**FILE NO.:** HR 16-09, HR 16-10, HR 16-11, HR 16-12, HR 16-13, and HR 16-14: Historic Review for the designs of seven (7) cottage style homes in the Canemah Historic District.

**REQUEST:** The applicant is requesting design approval for the construction of seven (7) new construction cottage style dwelling units, with preservation incentives to adjustment the front, side, and rear setbacks, in the Canemah Historic District.

**RECOMMENDATION:** Approval with Conditions

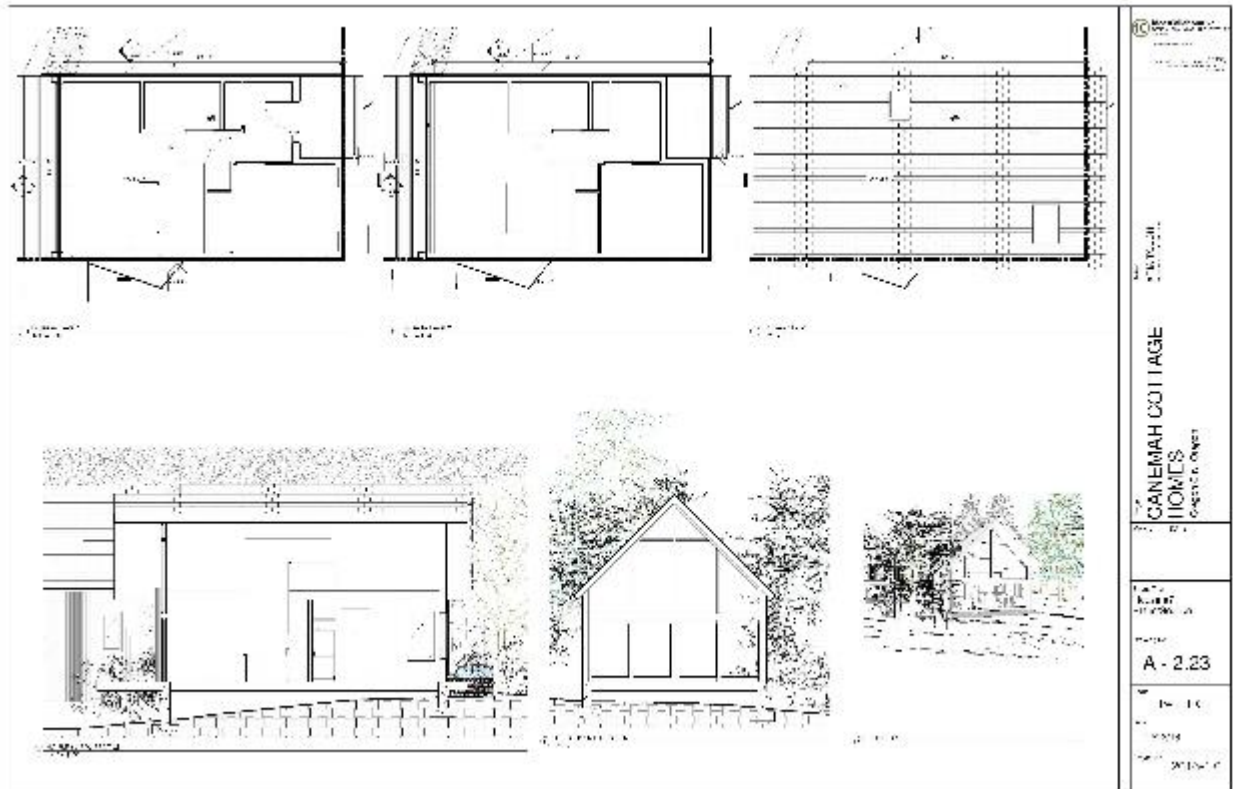
**Finding: Complies with Condition.** House four is a 600 square foot 1½ story modern Vernacular, completely sided in horizontal shiplap on the north and south side of the house, horizontal and vertical and horizontal shiplap on the east side of the house, and primarily windows with minor vertical shiplap on the west side of the house. This house is located approximately 10 feet to the south of house number six.

- a. Residential doors shall complement the design and detailing of the historic style with similar appearance to wood. Doors shall be designed in a stile and rail type; panel design; with upper portion glass. The primary door may be a solid panel door. Sliding doors are not permitted on any portion of the house.

- b. Windows shall match the member sizing, thickness and shadowline of painted wood windows. Windows shall also consist of the following designs: double, single hung, or casement. Wood clad shall be matching in color and finish. Non-wood fiberglass and aluminum windows are acceptable if in appropriate style, and matching wood in profile, shadowline, and if similar in color and finish. If a non-wood style is proposed, a sample is required to be approved by the Historic Review Board.

- c. Gable roof slopes shall have equal pitch. Gable primary roofs shall have a pitch of 8:12 or greater (6:12 for Bungalow). Porch or bay roofs may have lower slope, may have hip if style allows. Roofs shall have a minimum 1 foot overhang with a maximum of 3 feet.
